CITY PLANNING COMMISSION

APPLICATION: 1. Environmental Determination
2. Special Permit to establish a drive-through window in an existing fast food restaurant in the General Commercial (C-2) zone

LOCATION: 5625 Folsom Boulevard

APPLC. NO. P83-195

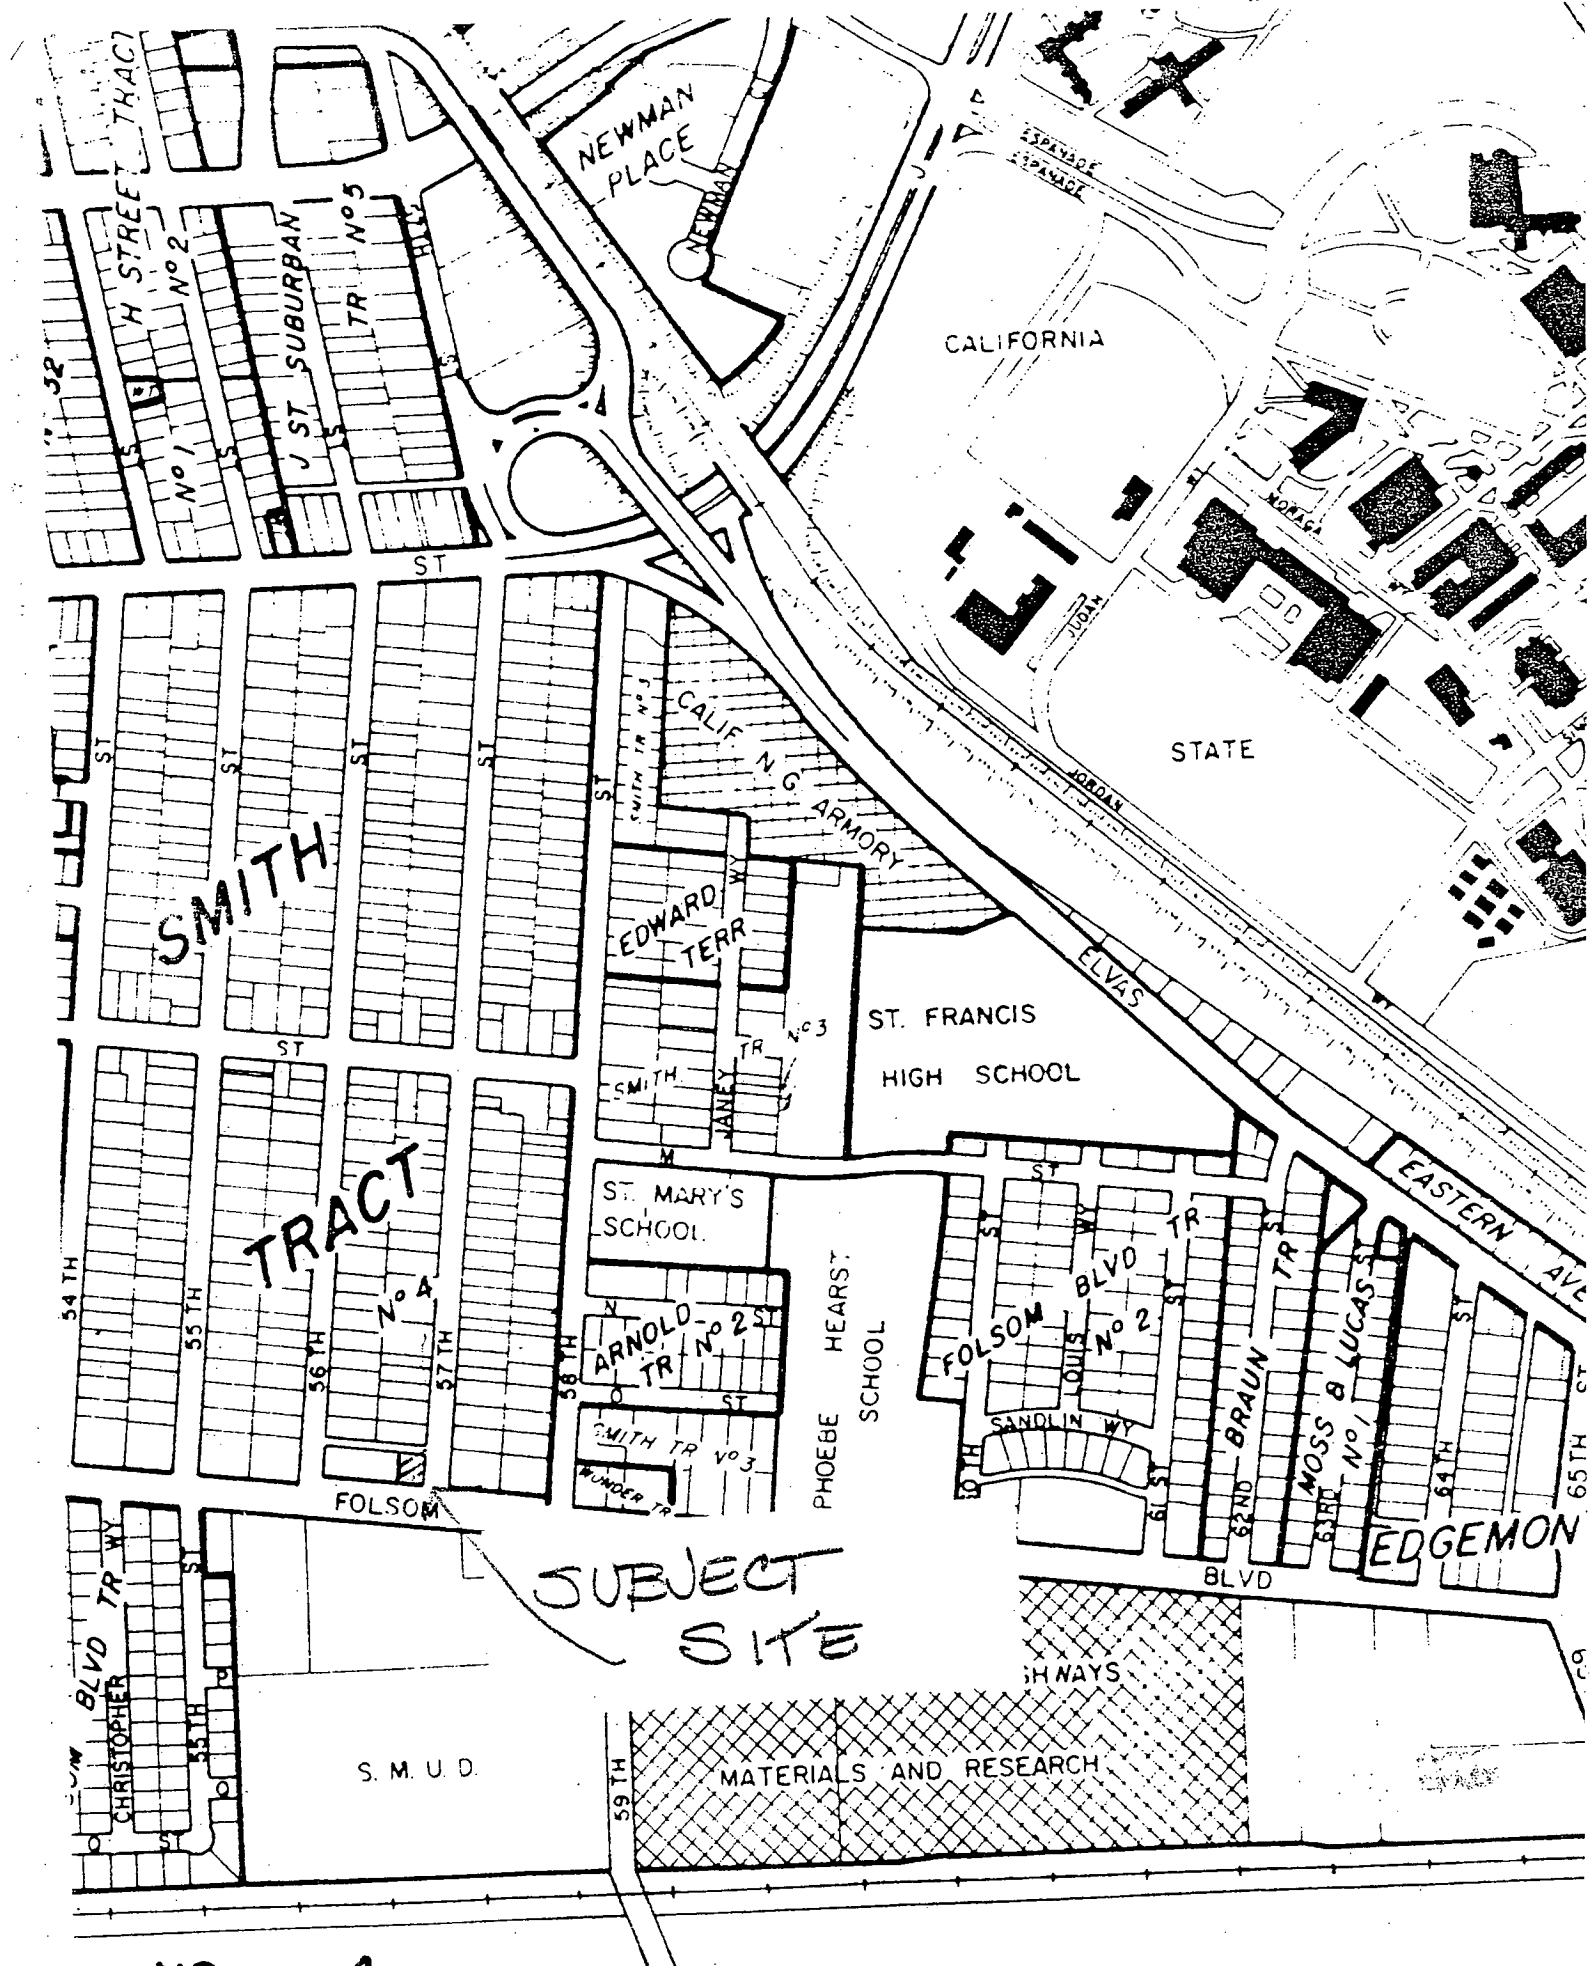
1. The drive-through entrance is proposed from 57th Street at the rear of the subject site. The adjacent property to the north of the subject site is developed with a single family dwelling. At the present time, separation between these properties is provided by a chainlink fence. The applicant has indicated that the chainlink fence will be replaced by a solid masonry wall. Although a masonry wall will reduce some noise to the neighboring residence, staff has concern that the additional traffic generated by the drive-through, and the noise from the menu box, will adversely affect the adjacent property.

2. As proposed, the drive-through lane does not have adequate stacking space for autos waiting to order. This may create traffic problems along 57th Street.

3. The City Traffic Engineer has reviewed the plans for the proposed drive-through and has indicated objections to the proposal because of the inadequate stacking space. The Traffic Engineer stated that the site plan would provide only enough space for one waiting auto and a second auto would be extending into the public right-of-way. Additional cars stacking along 57th Street could be hazardous to pedestrians and vehicle circulation.

4. As proposed, the drive-through addition will eliminate some existing on-site parking spaces; however, there will be adequate parking, based on a ratio of one required space per each three seats.

5. The subject fast food restaurant was not originally intended to have a drive-up window. The location of the structure and inadequate size of the lot make it difficult to provide a drive-through window with adequate stacking distance and maneuvering area.

STAFF RECOMMENDATION: Staff recommends the Planning Commission deny the request by the following actions:

1. Ratify the Negative Declaration; and
2. Deny the Special Permit, based upon the following Findings of Fact.

- a. As proposed, the special permit is not based upon sound principles of land use in that the drive-through facility will interfere with the residential use on the adjacent property;
- b. Granting the special permit will be detrimental to the public safety and welfare in that the stacking space is inadequate to accommodate autos waiting to order at the menu box, and it is anticipated that traffic problems will result along 57th Street.
